Addendum 78 – UN Regulation No. 79

Revision 4 - Amendment 9

Supplement 8 to the 03 series of amendments – Date of entry into force: 4 January 2023

Uniform provisions concerning the approval of vehicles with regard to steering equipment

“5.6.4.8.2. Detection area on ground level

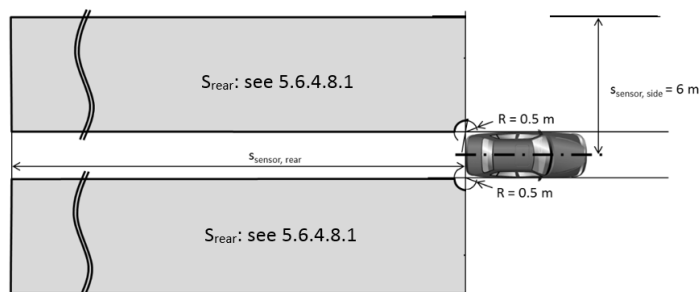
Paragraph 5.6.4.8.2., amend to read:

The vehicle system detection area on ground level shall be at minimum as shown in the figure below.”

Additionally, for trailers supporting lane change function, the detection area specified in paragraph 5.6.4.8.2. shall be extended to the sides of the trailer including the coupling device.”

- (a) The detection area specified in paragraph 5.6.4.8.2. shall apply to the sides of the power-driven vehicle, while the detection behind the rearmost point of the vehicle shall be deemed optional.
- (b) The vehicle shall fulfil the requirements of paragraph 5.6.4.9.
- (c) The ACSF of Category C shall be deactivated (off mode) if the coupled trailer of Category O₃ or O₄ is not fulfilling the requirements of paragraph 5.6.4.9. (Unless the power-driven vehicle is able to assist lane change when coupled to a trailer not supporting lane change functions, as specified in paragraph 5.6.4.8.1.3.).”

- (c) Additionally, the detection area specified in paragraph 5.6.4.8.2. shall be extended to the sides of the combination.”
